From: Campos, Alicia@Energy
Sent: Wednesday, February 20, 2013 2:41 PM
To: Energy - Docket Optical System
Subject: 12-AFC-03 Redondo Beach Energy Project - Public Comment/Galen Hunter, Dated February 20, 2013 - Please Docket and Post to the Web

Comments on the data adequacy of the Application for Certification for Redondo Beach Energy Project (12-AFC-03)

- Geologic Hazards and Resources Assessment
- Applicant Data Adequacy Supplement TN-69327.

_____ Local Hydrogeologic Conditions Redondo Beach Site _____

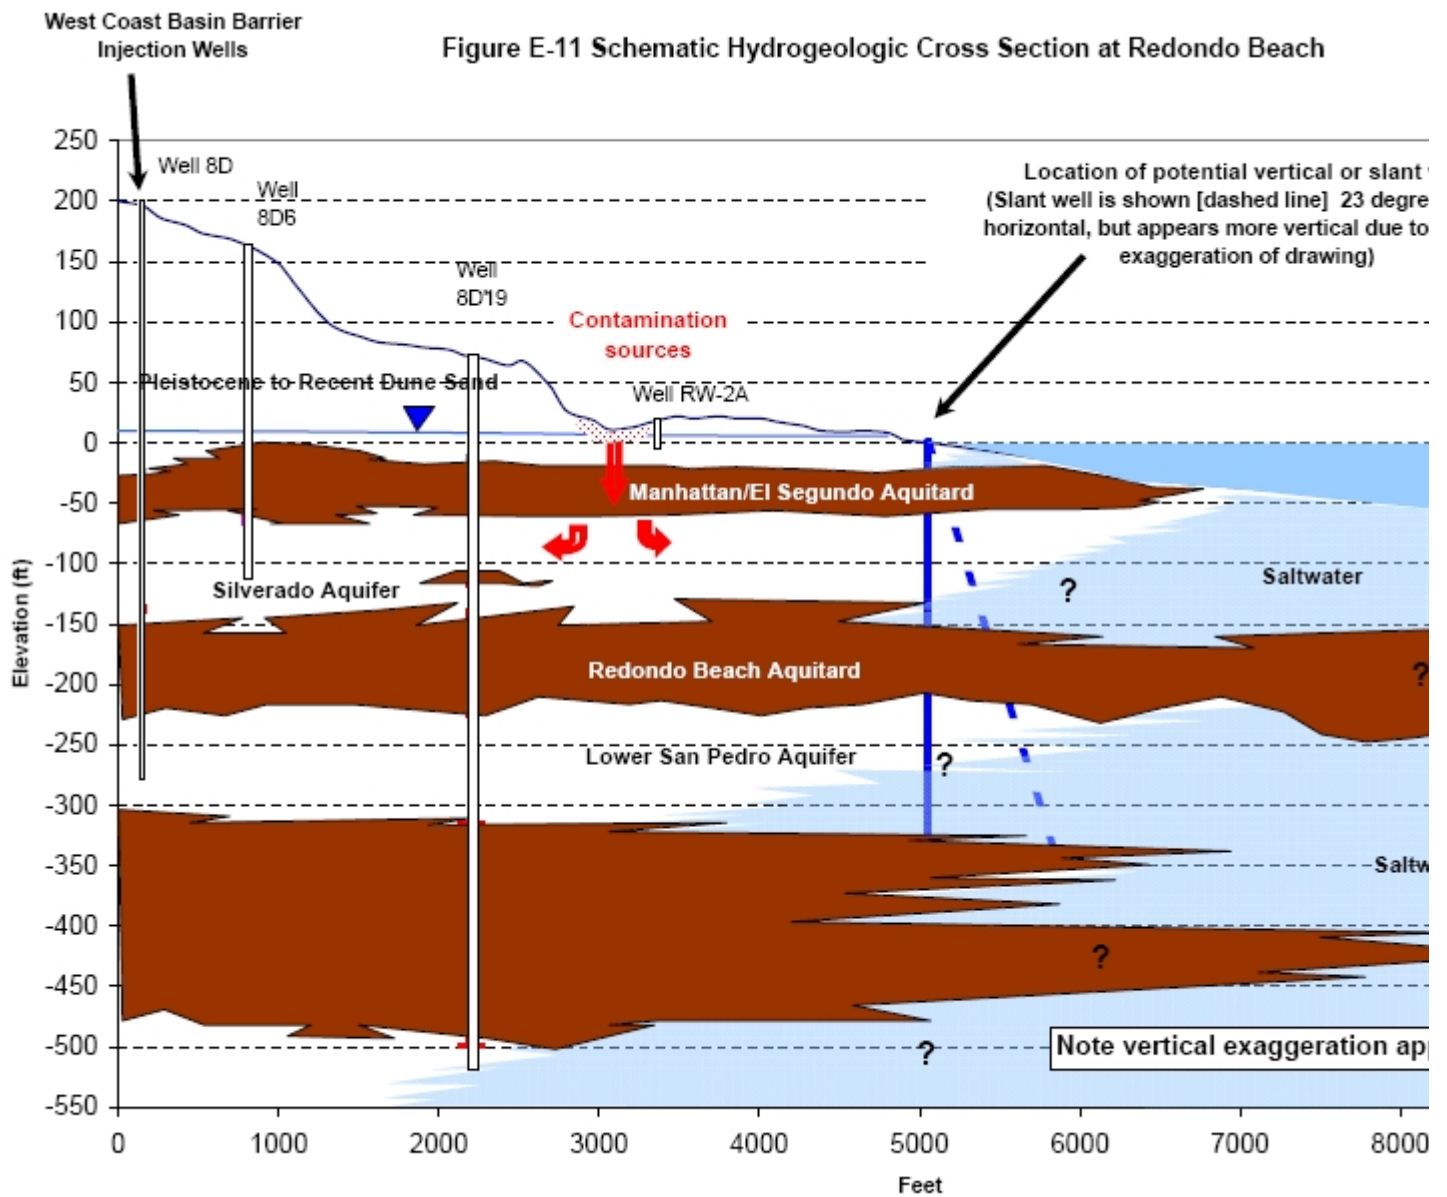
Note the image below. The image shows “Contamination sources” at the site – the RBEP site - reaching the Manhattan/El Segundo Aquitard to the Silverado Aquifer at least. Evidently, the site is known to be polluted to the core. This pollution data is not in the AES Application for Certification.
